EEG-52

AN EVALUATION OF AIR EFFLUENT AND WORKPLACE RADIOACTIVITY MONITORING AT THE WASTE ISOLATION PILOT PLANT

William T. Bartlett

Environmental Evaluation Group
New Mexico

Figure 3. Picture of Underground Exhaust Stack and Station A
(view is to the northeast)

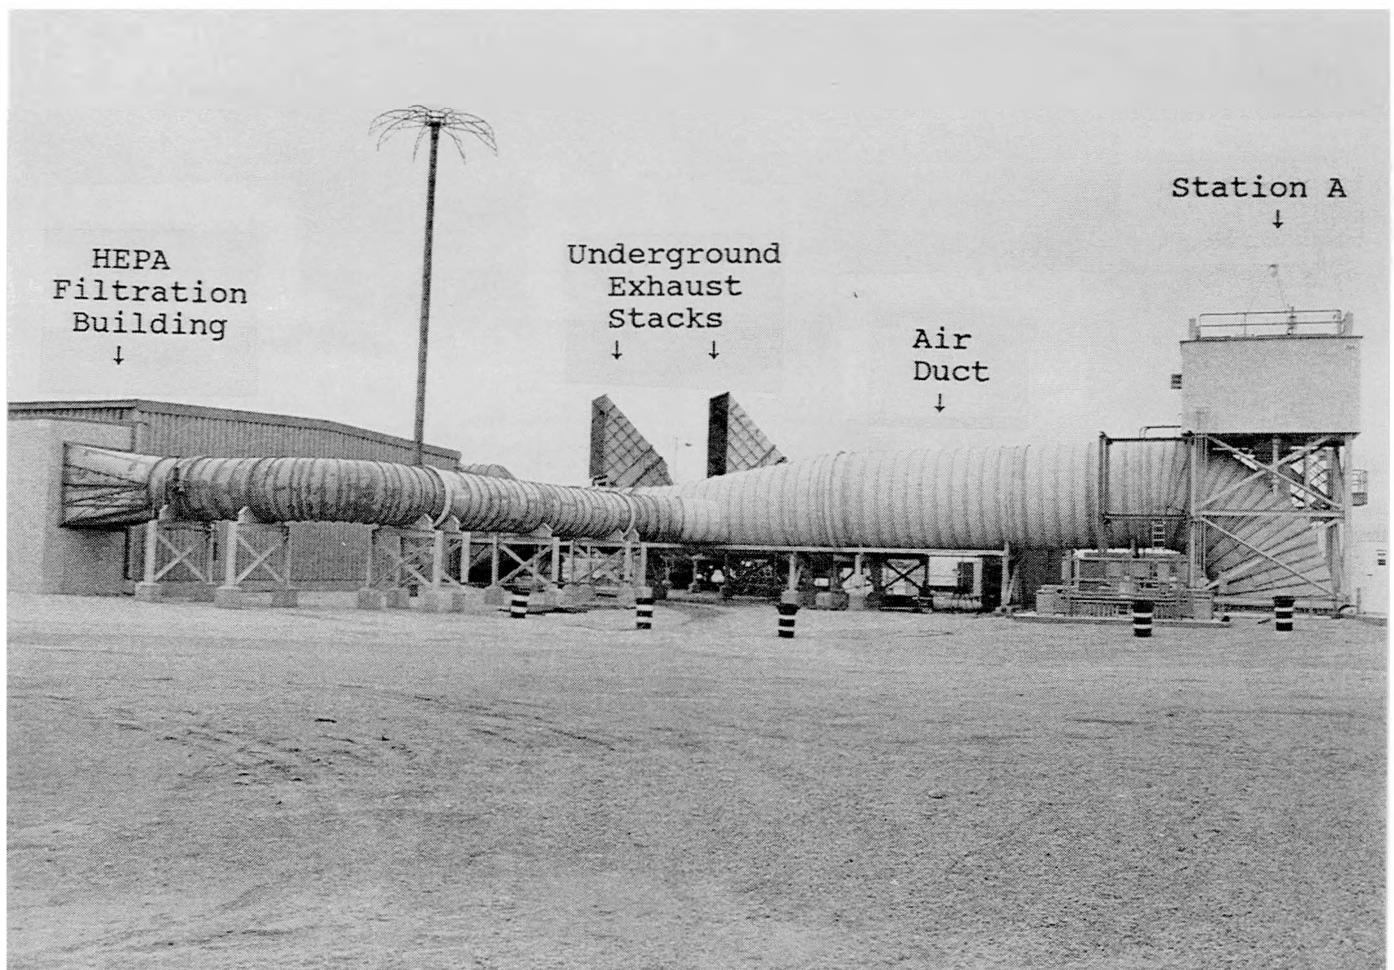
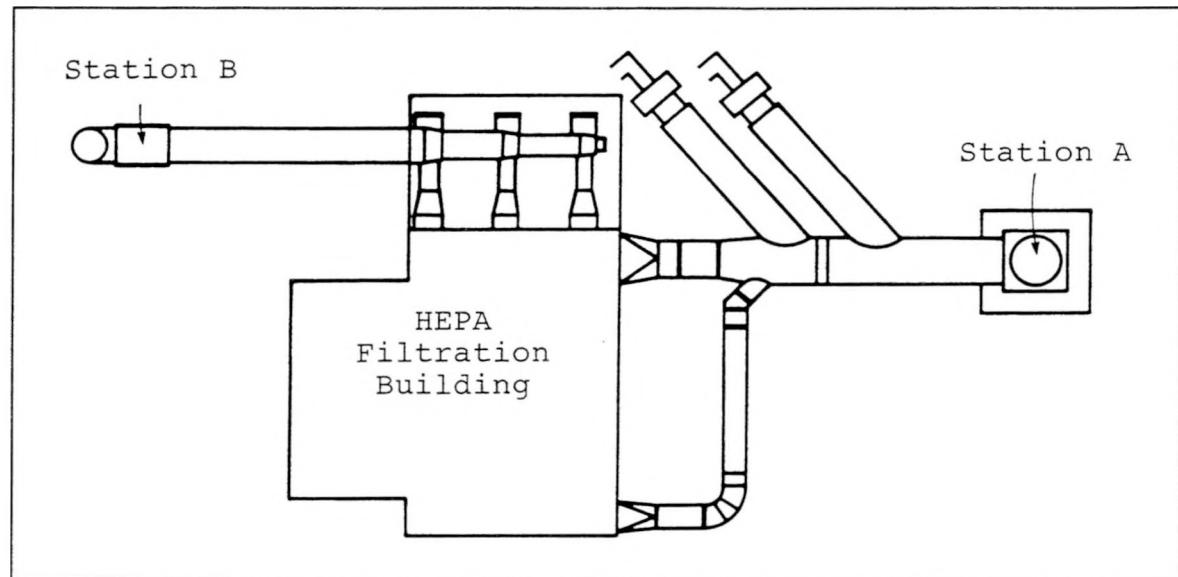
At the WIPP, there are two stacks, approximately 10 meters in height, which discharge at a 45° angle to the ground horizon (see Figure 3). This design is not optimum for dispersing and diluting effluent. The traditional design, a vertical stack, is assumed in the CAP-88 code programming. The code also allows for an area or ground release. Because of the unusual WIPP stack design, the Stoller report calculations assume an effective stack height based on the stack angle. The vertical stack modeling methodology is used in lieu of an angular method.

In addition to ground release corrections, building wake effects must be considered. As shown in Figure 3, the HEPA filtration building is located approximately 8.5 meters from, and in direct line with, the horizontal releases from the underground exhaust stack. The HEPA filtration building roof is at approximately the same elevation as the lower portion of the rectangular exhaust stack aperture. As situated, the exhaust stack is in the SE quadrant of the facility secured area. The prevailing horizontal exhaust direction will cross diagonally through key on-site building locations. Backwash and fumigation conditions would likely occur in areas occupied by on-site personnel. This scenario was presented to the DOE at the February 1991 Quarterly Meeting. The DOE has not responded, and there apparently are no empirical data to verify exhaust effluent patterns.

- (4) The on-site dose calculation codes should be revised to include backwash and building wake effects. In the event calculation codes can not be appropriately revised and certified, then stack-related empirical corrections factors should be experimentally derived for use in on-site and off-site plume dispersion calculations. This information is essential to establishing effluent CAM alarm levels.

Figure 8. CAM 121/122 at S1600 and E300

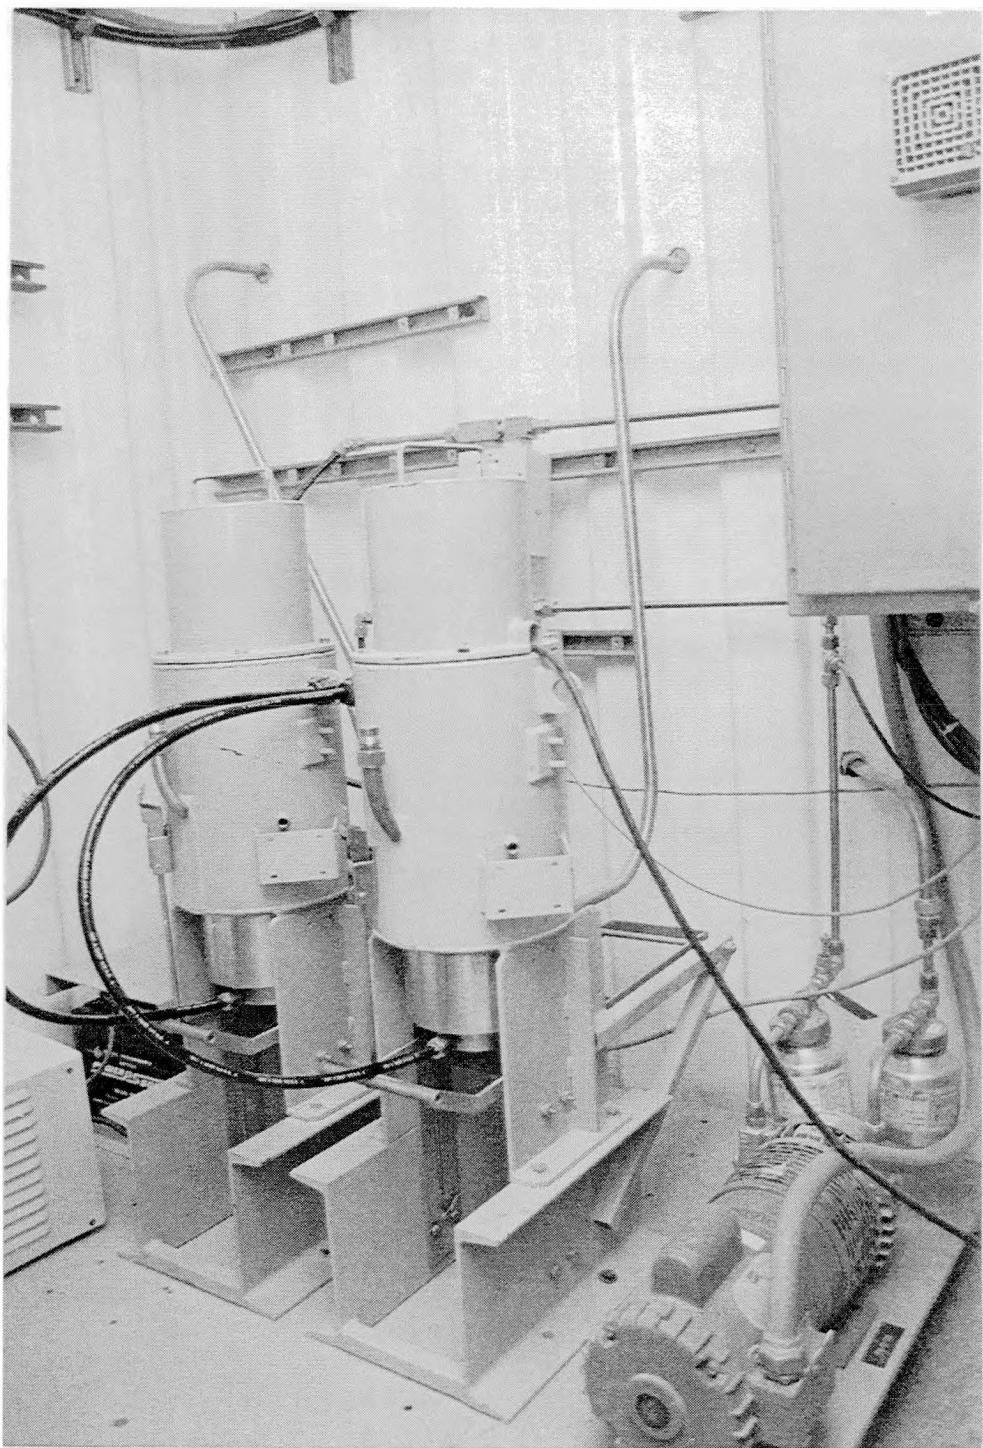
On September 12, 1992, EEG staff found both Station A alpha CAM systems red-tagged. The red tag normally indicates that equipment should not be used. The DOE stated that the red tag was placed on the equipment in January 1992 because out-of-specification detector/filter spacers were being used.

Figure 9. CAM 121 Sample Line Penetration at S1600 and E300

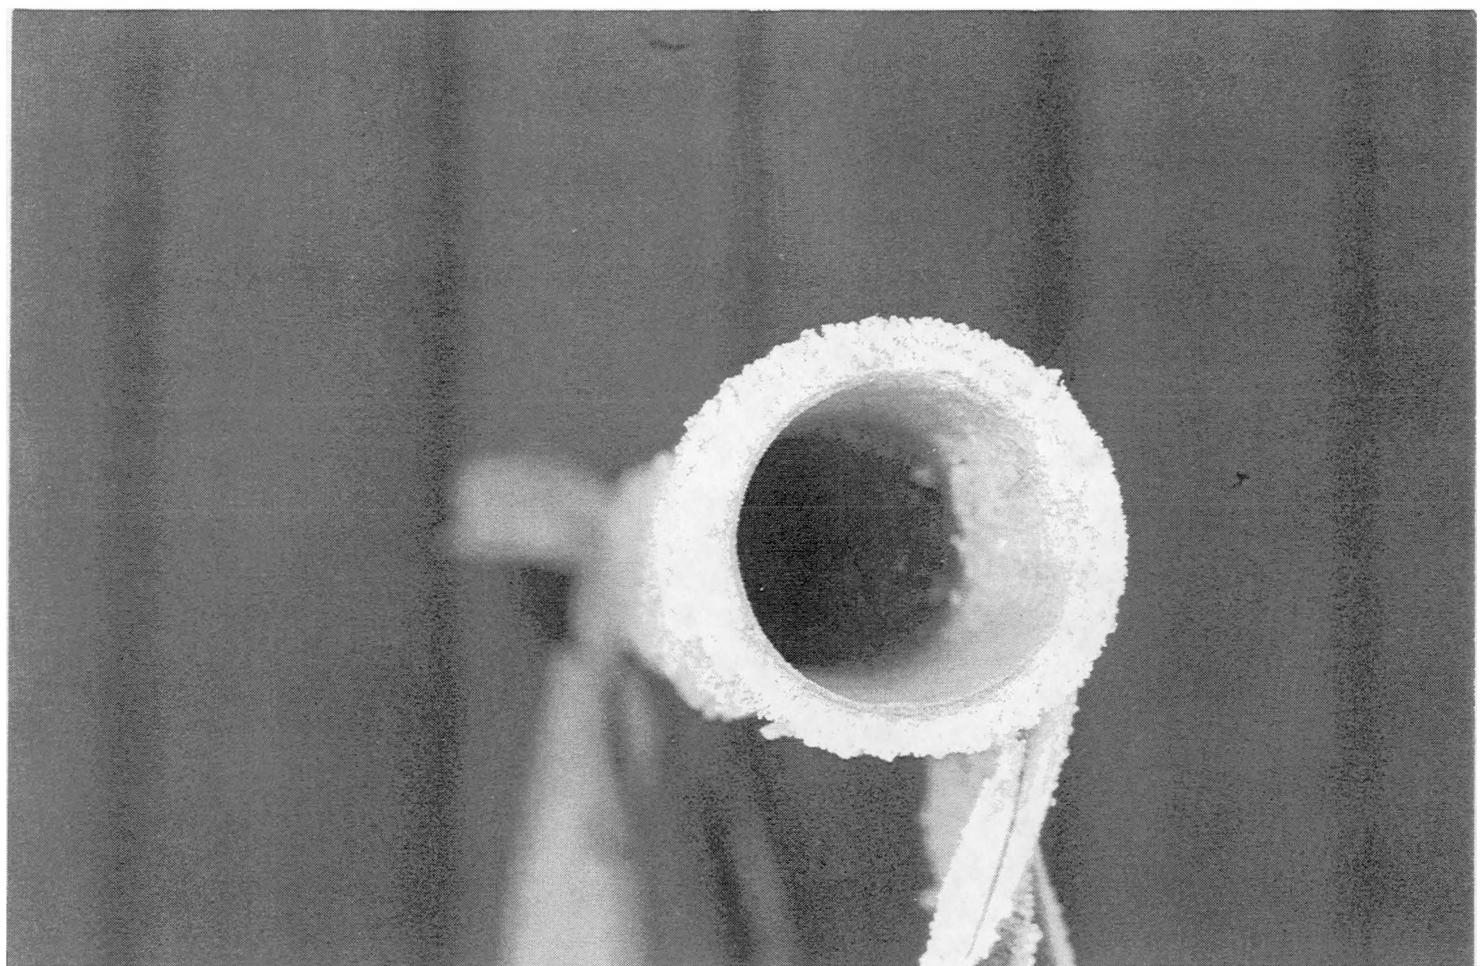
The Figure 9 photograph was taken on September 11, 1992 and shows one of the sample line penetrations into the E300 drift by CAM 121 pictured in Figure 8. There is significant salt buildup on the outside and inside of the sample line. The other sample line had similar salt buildup.

Figure 10. CAM 127/128 Station D Sampling Probe

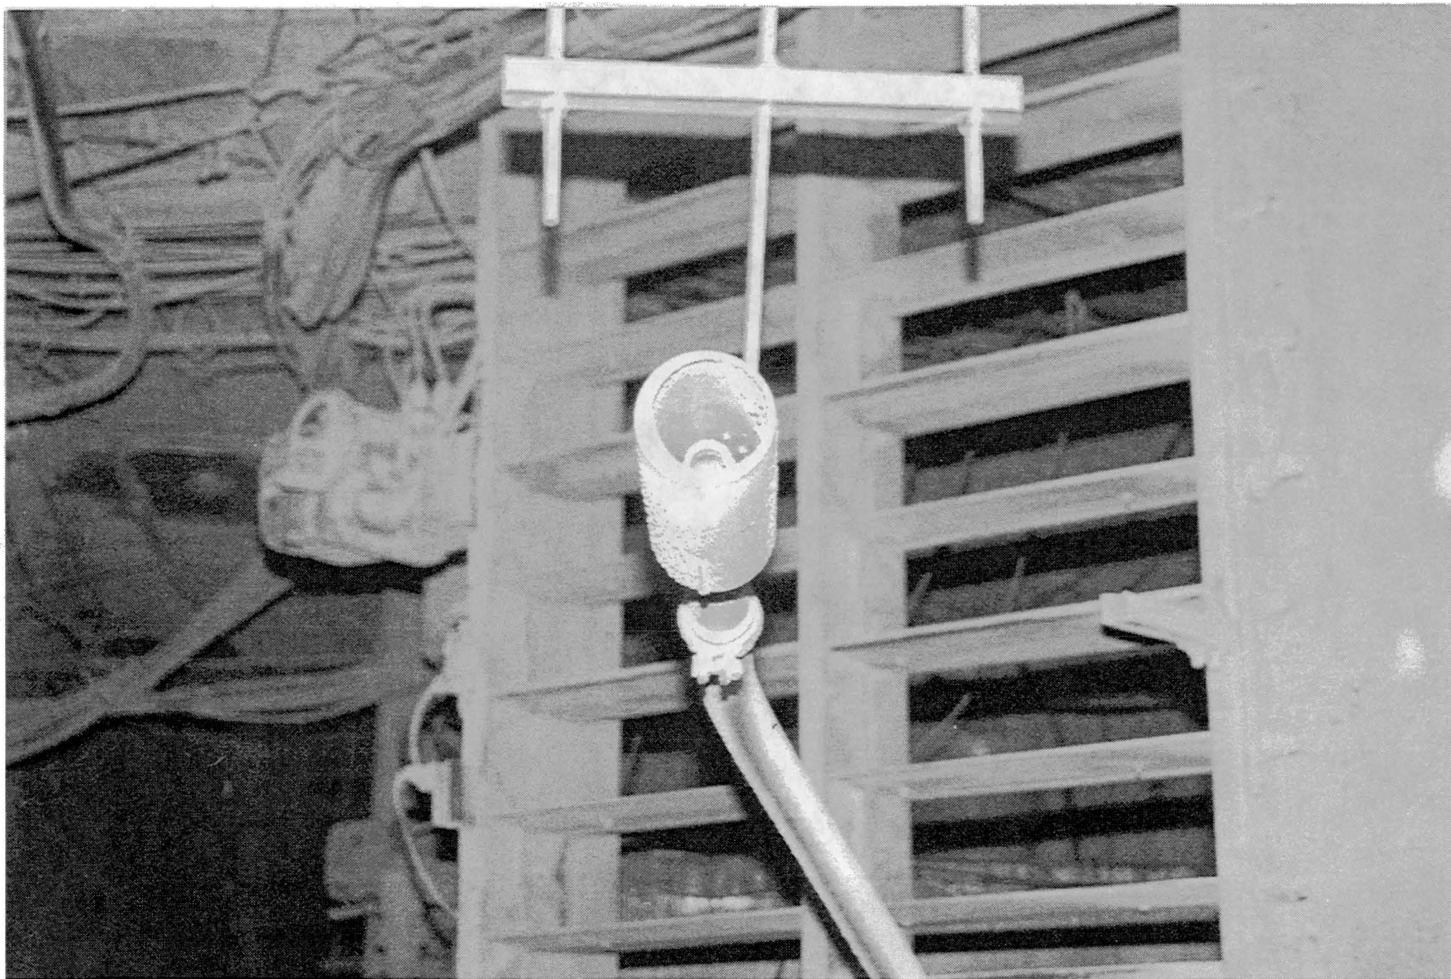
Figure 10 shows one of the Texas A&M modified probes at Station D with approximately 16 mm buildup of salt. The EEG provided an expert report (Neill 1989b) from the Southern Research Institute which suggested that as little as 5 mm salt buildup on the shroud would result in unacceptable shroud performance.

Figure 13. CAM Data Availability

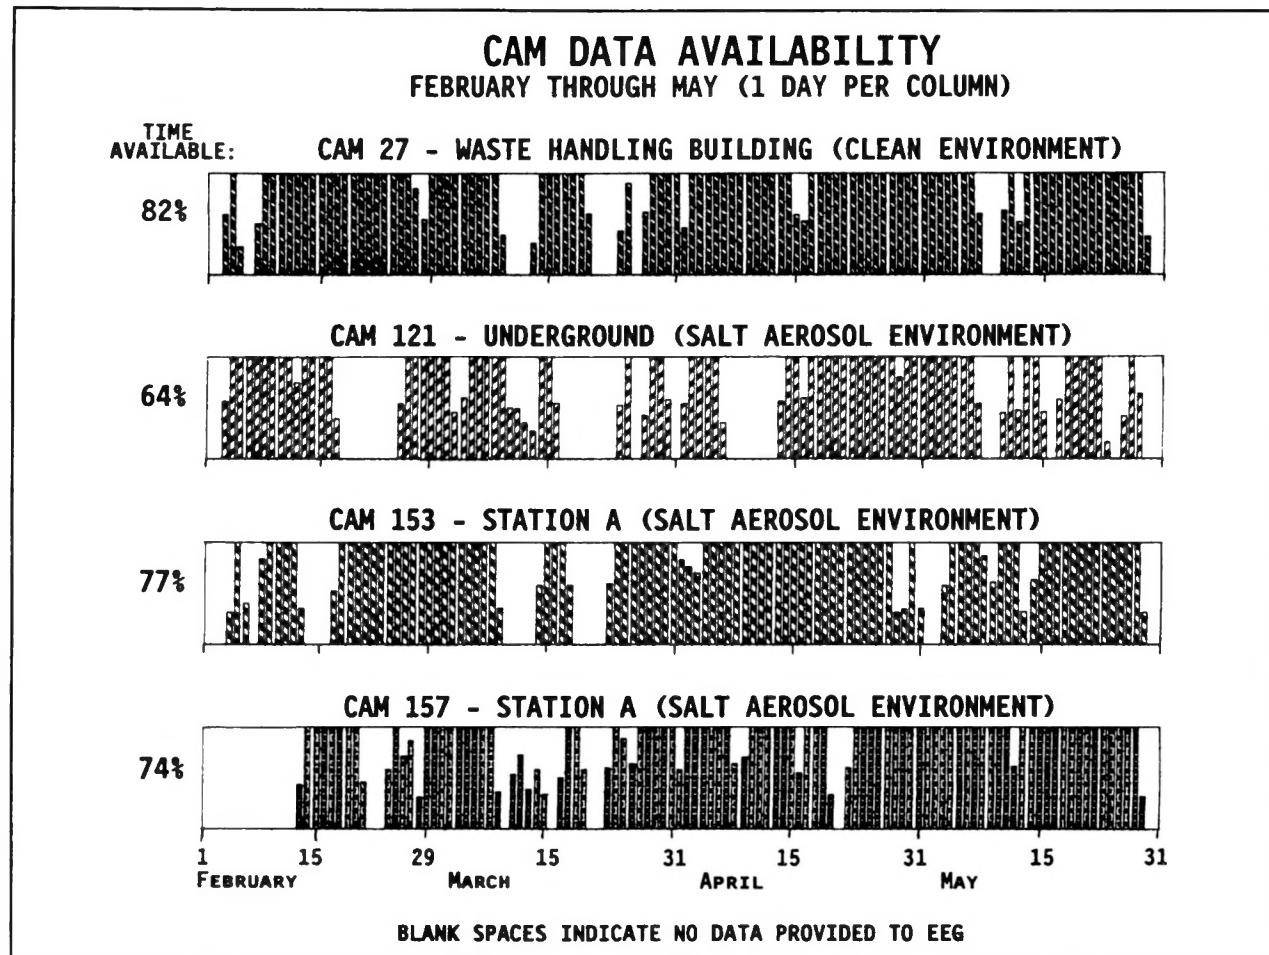
Figure 13 is a bar graph indicating the availability of CAM data from February to June 1992. Each bar on the chart represents a single day's data. Blank regions indicate days or portions of days when data were not available.

The DOE has not been able to provide specific reasons for lack of data, but general statements have been made that no data could mean that the computer archiving may have failed, plant power outages may have occurred, maintenance activities required interruptions, or possibly detector/equipment failures.

Figure 14. Example of CAM 121 Degraded Spectrum

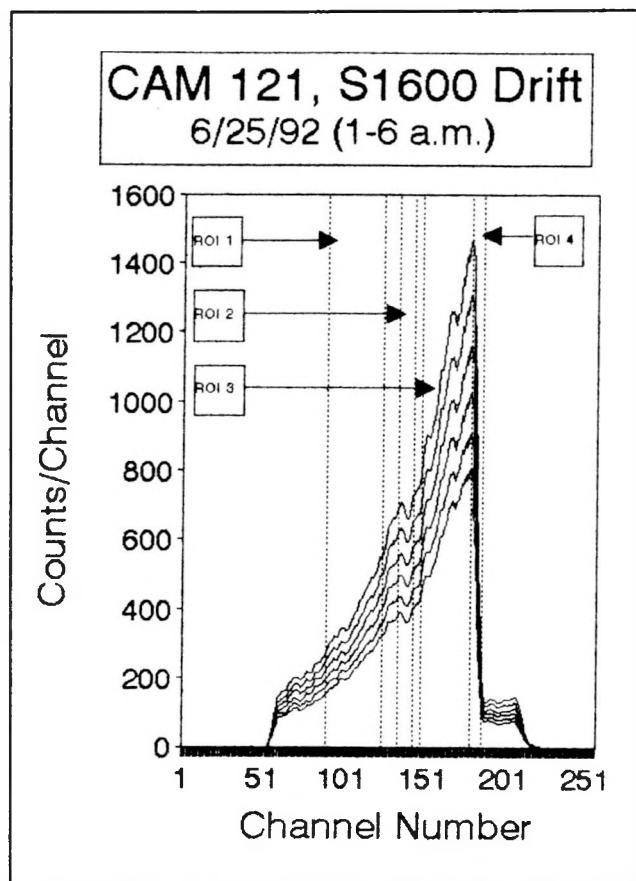
CAM 121 is the only underground CAM for which data are provided. Data are frequently not available, and spectra are often degraded. Many of the example spectra are rated as poor or unusable (Figure 14 and Appendix F-3 to F-5).

Figure 19. Degraded Spectra on High Salt Aerosol Day

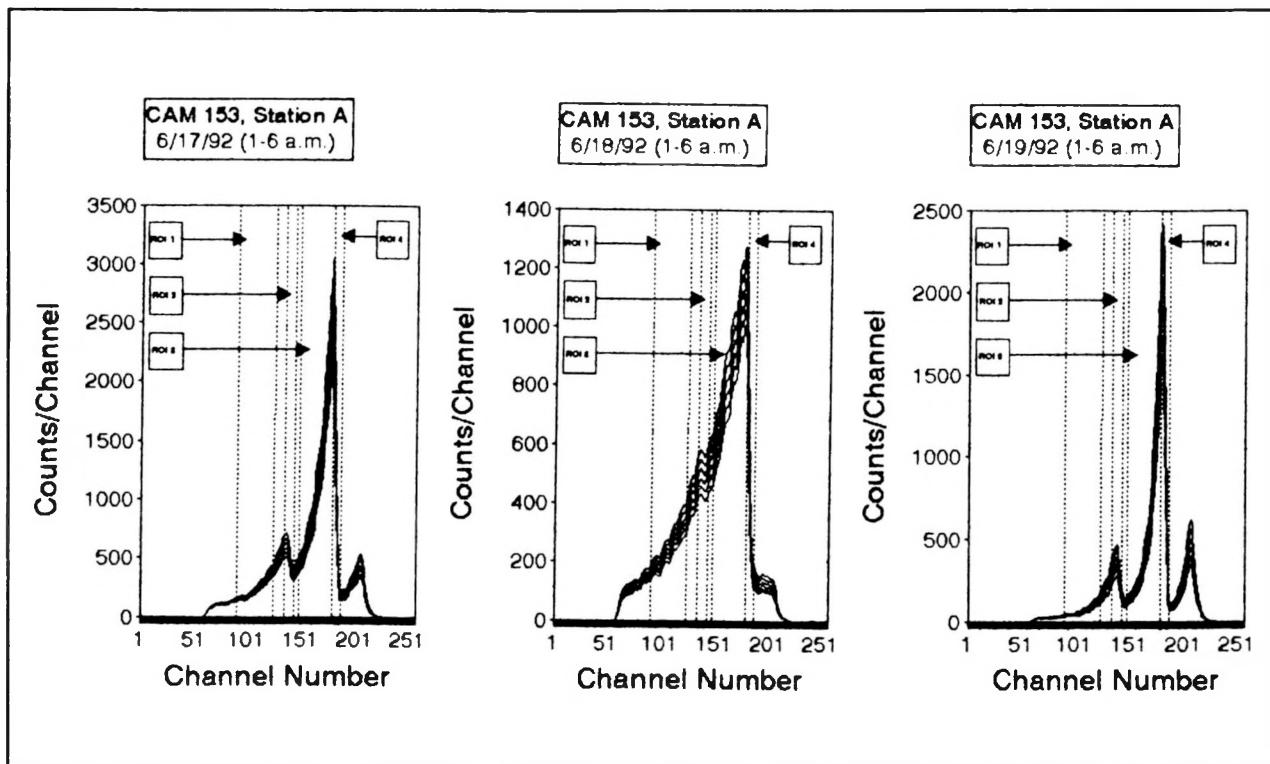
High filter salt loading can cause degraded spectra and negative plutonium channel counts. CAM 157 and 153 spectra were selected from 6/18/92 when filter salt loading was abnormally high (0.39 mg/m^3), and the spectra were significantly degraded (Figure 19 and Appendix F-15). On 6/17 and 6/19, the salt loading was much lower (0.011 and 0.070 mg/m^3 , respectively), and the spectra were relatively good. The spectra on 6/18 are particularly revealing because both CAM 153 and 157 spectra are similarly degraded, and on the days before and after 6/18, spectra are reasonably good.

During the first six hours of 6/18, the CAM 153 plutonium channel count average was a negative 12 CPM. During this same time

Figure 20. Effective CAM-153 Alarm

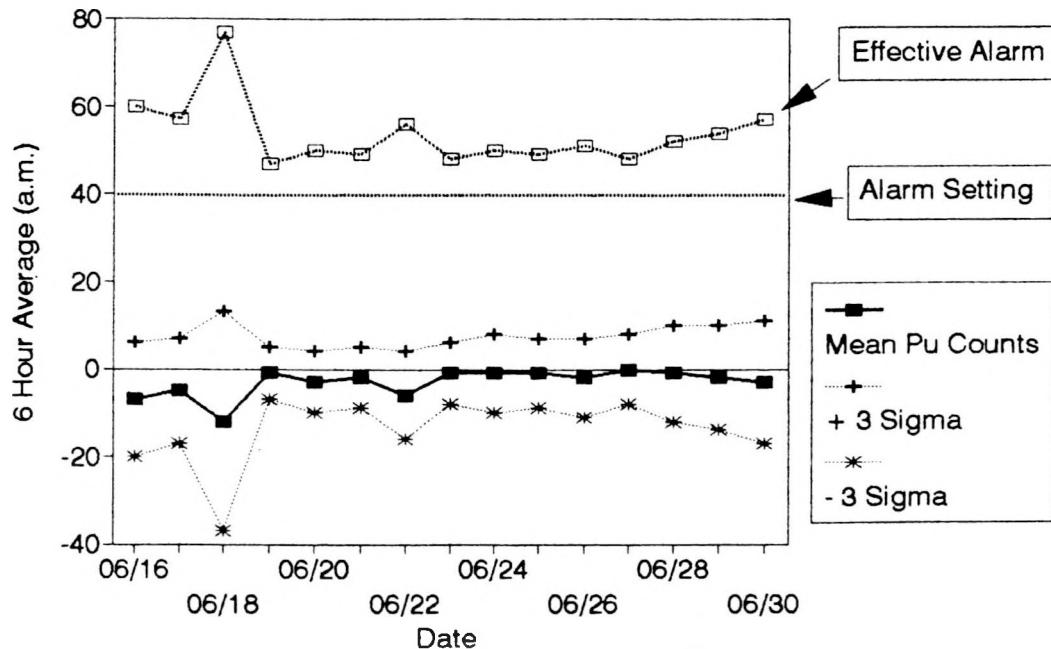
When plutonium channel counts are negative, the effective alarm level is increased. The stated WIPP effluent alarm level is 40 CPM, but Figure 20 data indicate that the effective alarm level is higher than 40 CPM when negative excursions and range variations are considered. When errors caused by the wide range of allowed detector efficiencies, reproducibility of the measurements, or other system errors are considered, the effective alarm level may be much higher than the actual setting.

- (1) Alpha and beta CAMs should be fail-safe, and methods should be developed to immediately identify non-operational status. These modifications are necessary to satisfy FSAR requirements for waste handling, ventilation diversion, and limiting conditions for operation.
